07-15-21 - CITY COMMENTS	
--------------------------	--

HOMWOOD SUITES
3500 S. MERIDIAN
SOUTH HILL MALL
PUYALLUP, WA 98373

OFFSITE ADA RAMP IMPROVEMENTS DEMOLITION PLAN
C-3.1

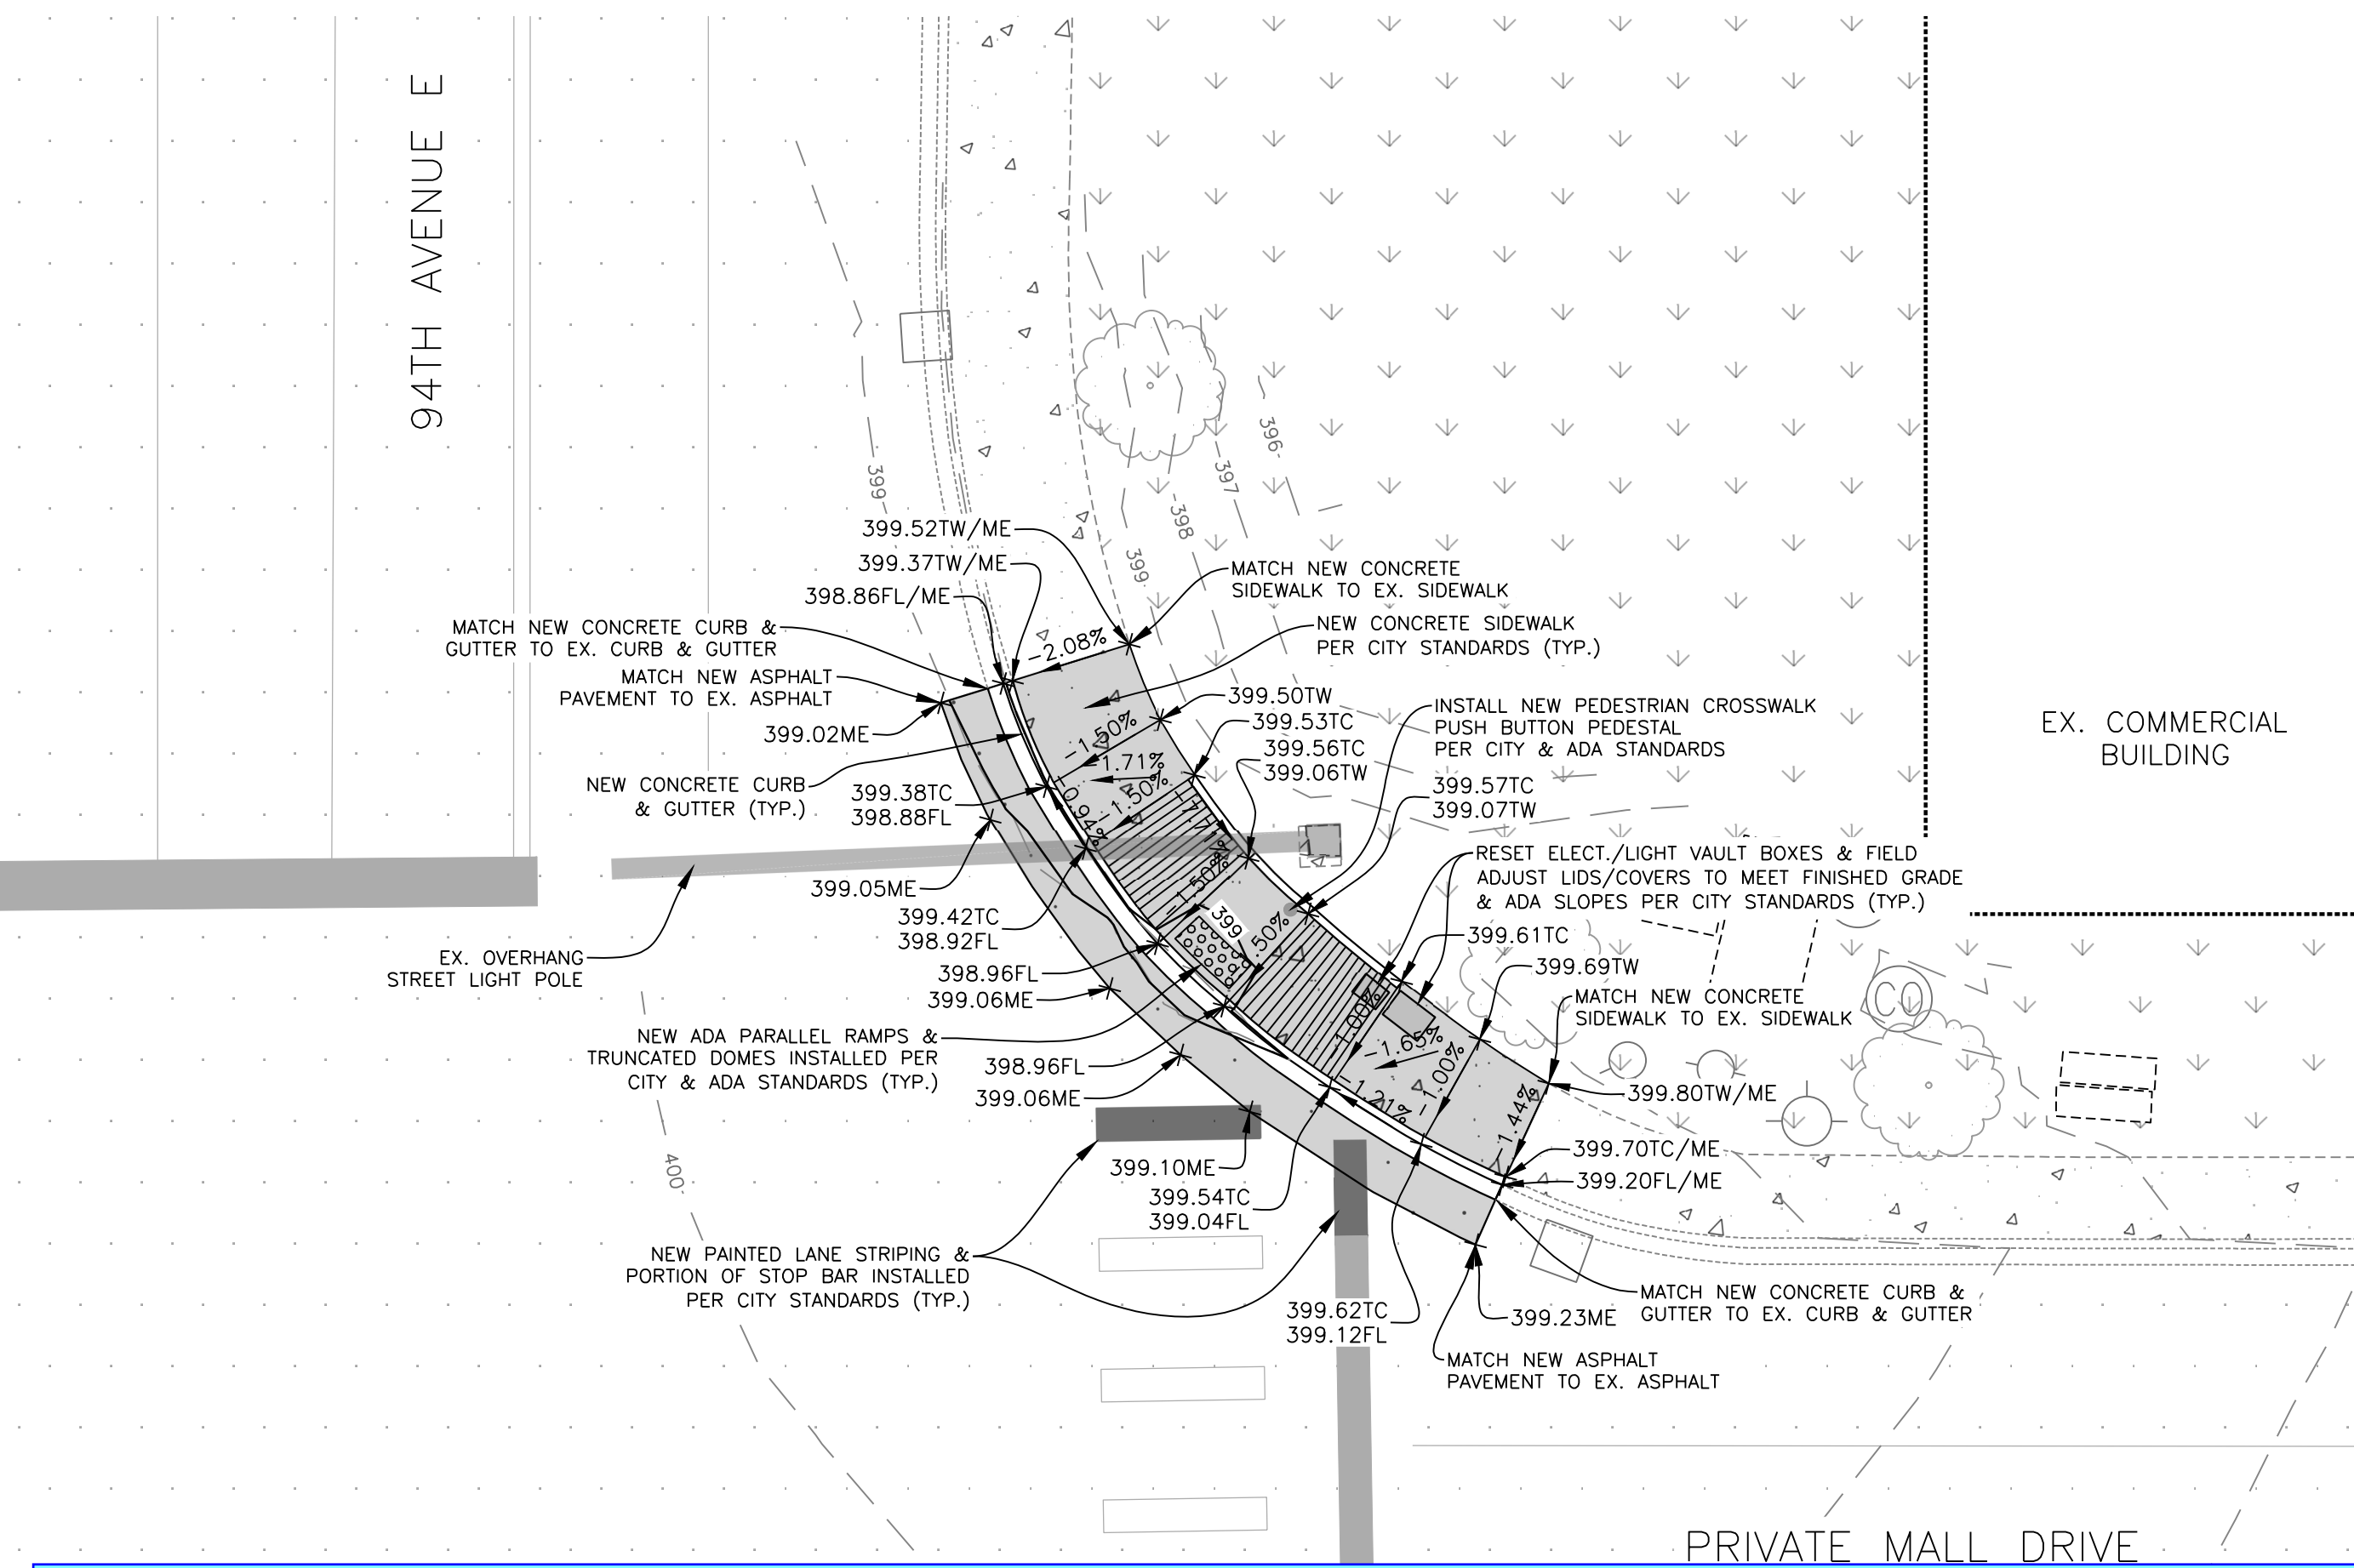
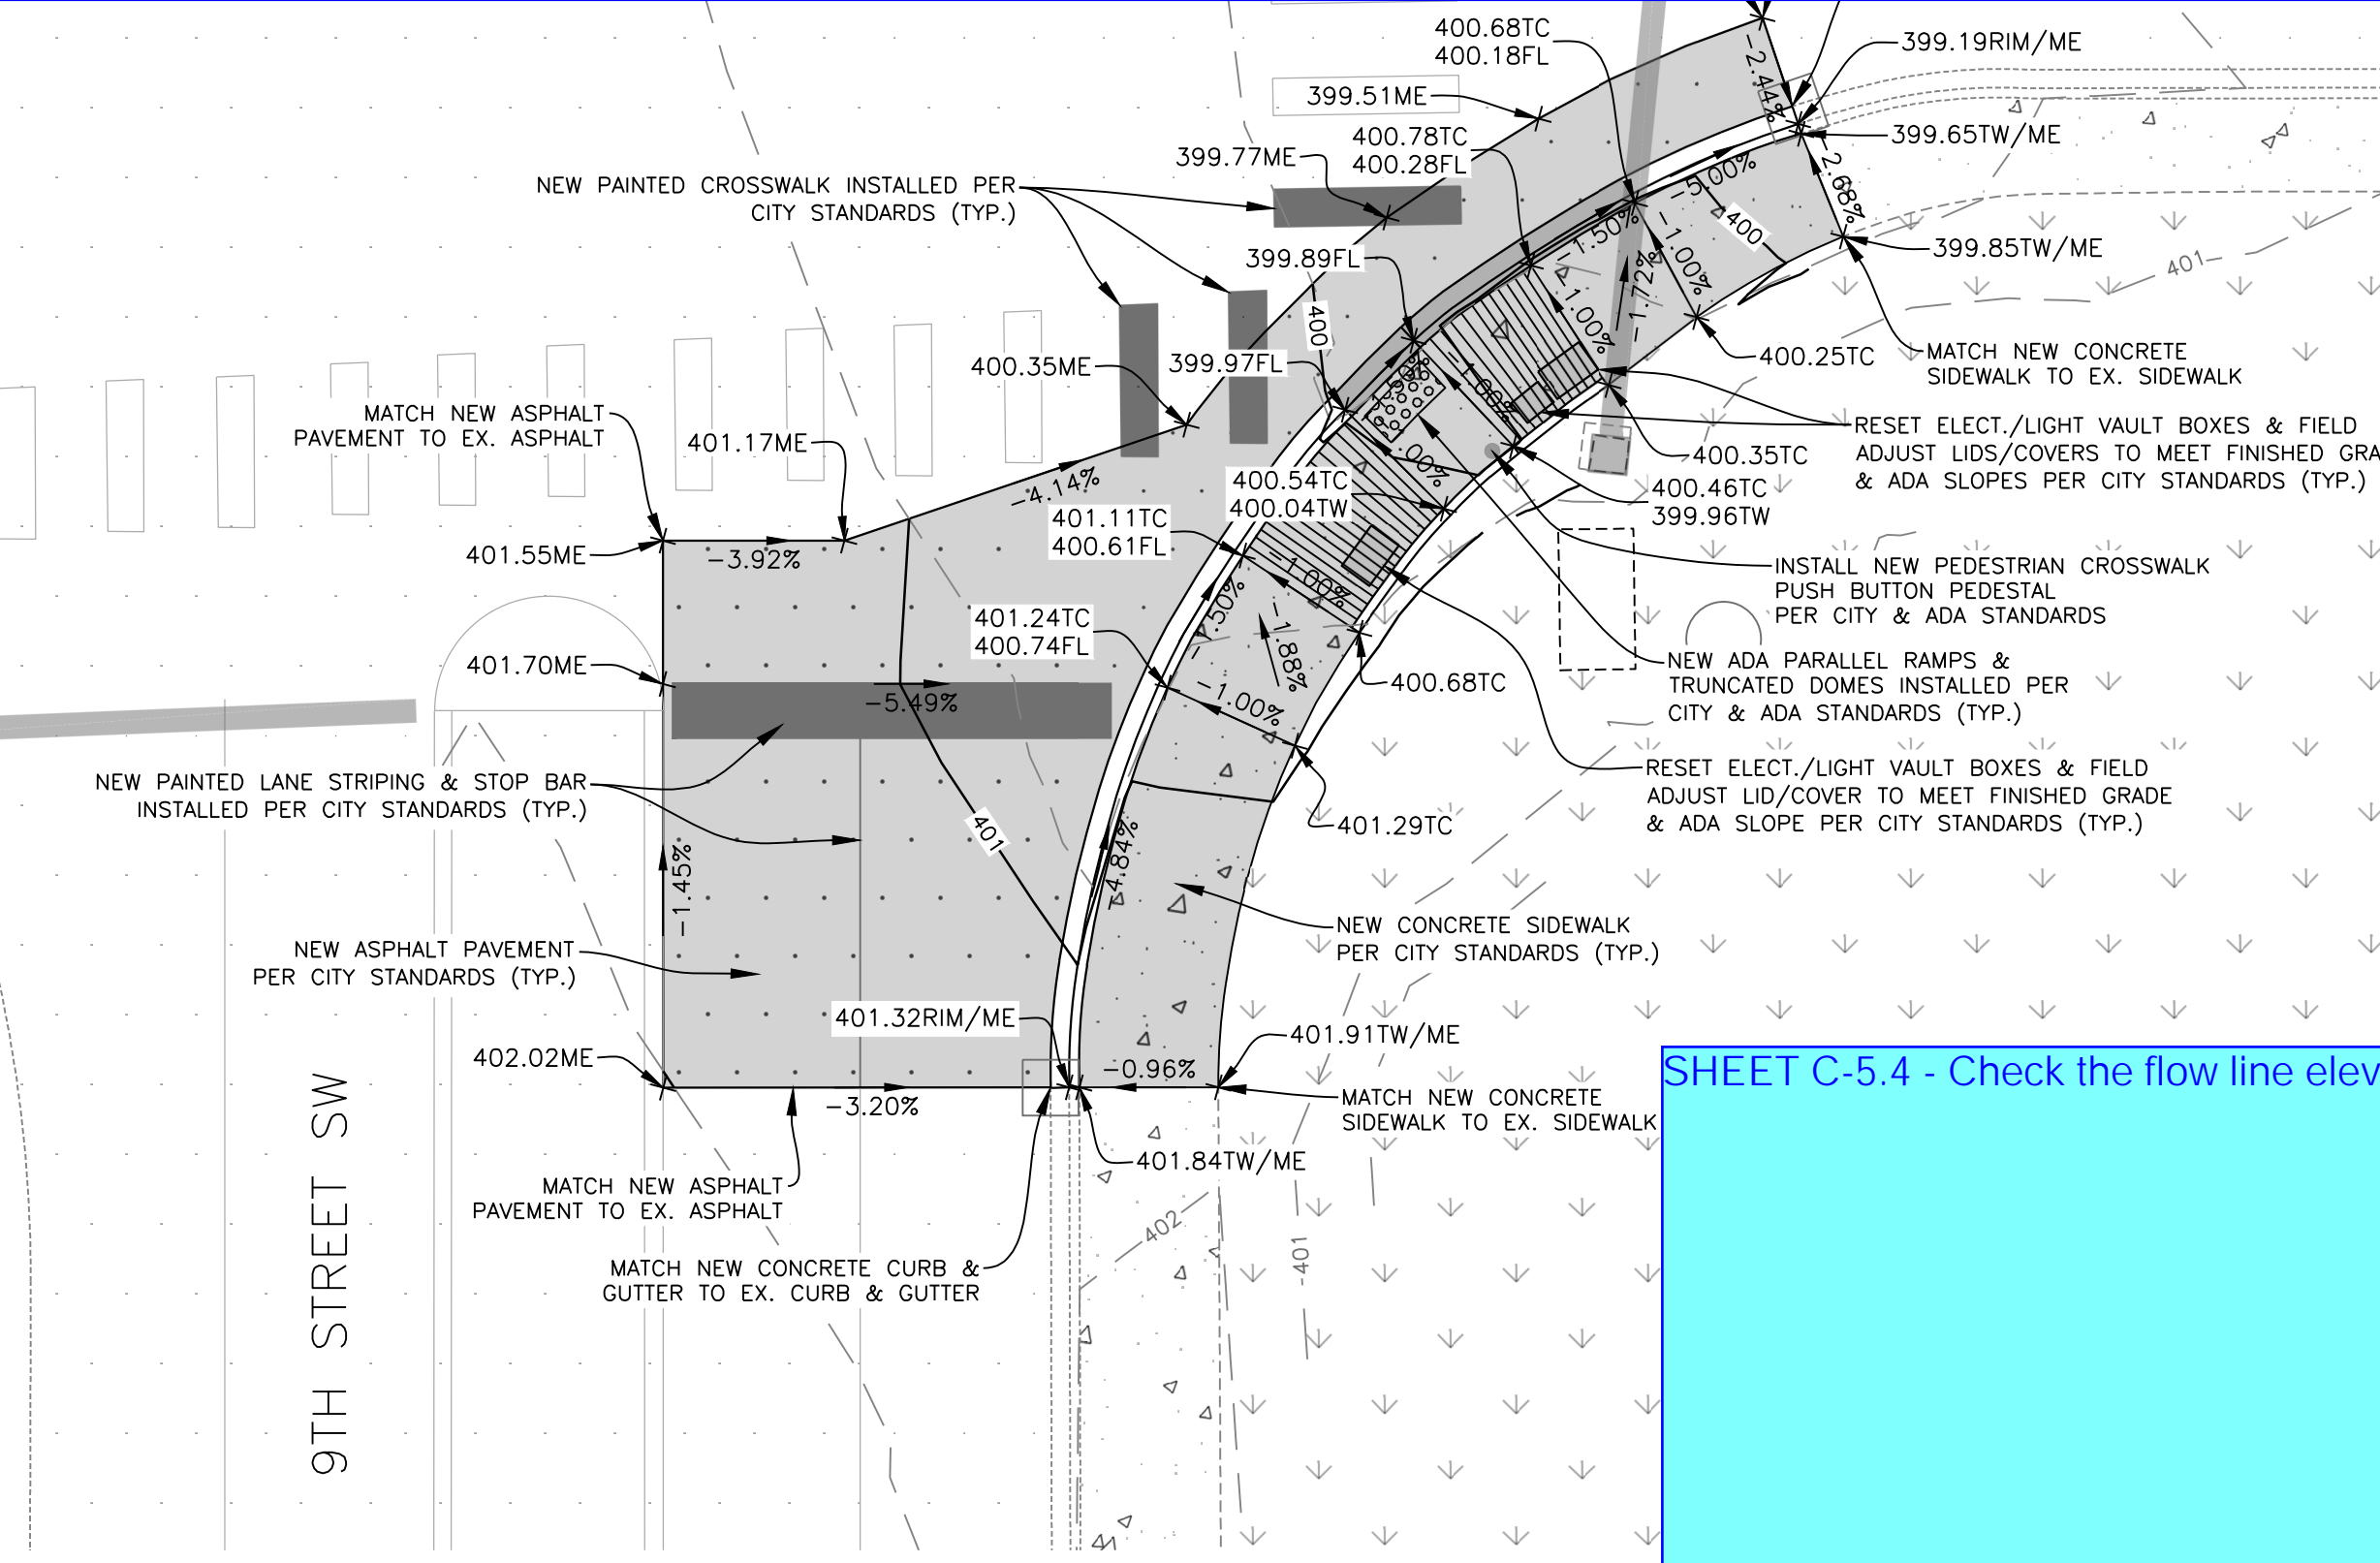
SHEET C5.4 - On the southeast corner of the intersection, the intent of the design between the landing and the north match existing joint is unclear as to which of the three sections is ramp and which of the three are sidewalk. The curb and gutter top elevations are at 399.10ME, 399.54TC, 399.04FL, 399.52TW/ME, 399.37TW/ME, 399.50TW, 399.53TC, 399.56TC, 399.06TW, 399.57TC, 399.07TW, 399.61TC, 399.69TW, 399.80TW/ME, 399.70TC/ME, 399.20FL/ME, 399.62TC, 399.12FL, 399.23ME. The curb and gutter top elevations are at 399.10ME, 399.54TC, 399.04FL, 399.52TW/ME, 399.37TW/ME, 399.50TW, 399.53TC, 399.56TC, 399.06TW, 399.57TC, 399.07TW, 399.61TC, 399.69TW, 399.80TW/ME, 399.70TC/ME, 399.20FL/ME, 399.62TC, 399.12FL, 399.23ME. The curb and gutter top elevations are at 399.10ME, 399.54TC, 399.04FL, 399.52TW/ME, 399.37TW/ME, 399.50TW, 399.53TC, 399.56TC, 399.06TW, 399.57TC, 399.07TW, 399.61TC, 399.69TW, 399.80TW/ME, 399.70TC/ME, 399.20FL/ME, 399.62TC, 399.12FL, 399.23ME.

SHEET C-5.4 - 3 of 4 ramps do not include running slopes. Provide conforming slopes for all ramps.

SHEET C5.4 - The elevation shown on the southeast corner of the intersection for the back of sidewalk TC at the north end of the ramp is 399.65TW/ME. The elevation shown on the southeast corner of the intersection for the back of sidewalk TC at the south end of the ramp is 399.85TW/ME. The elevation shown on the southeast corner of the intersection for the back of sidewalk TC at the north end of the ramp is 399.65TW/ME. The elevation shown on the southeast corner of the intersection for the back of sidewalk TC at the south end of the ramp is 399.85TW/ME.

SHEET C5.4 - The elevation shown on the southeast corner of the intersection for the back of sidewalk TC at the south end of the ramp is 399.85TW/ME. The elevation shown on the southeast corner of the intersection for the back of sidewalk TC at the north end of the ramp is 399.65TW/ME. The elevation shown on the southeast corner of the intersection for the back of sidewalk TC at the south end of the ramp is 399.85TW/ME. The elevation shown on the southeast corner of the intersection for the back of sidewalk TC at the north end of the ramp is 399.65TW/ME.

SHEET C-5.4 - Check the flow line elevations at 399.65TW/ME and 399.85TW/ME.
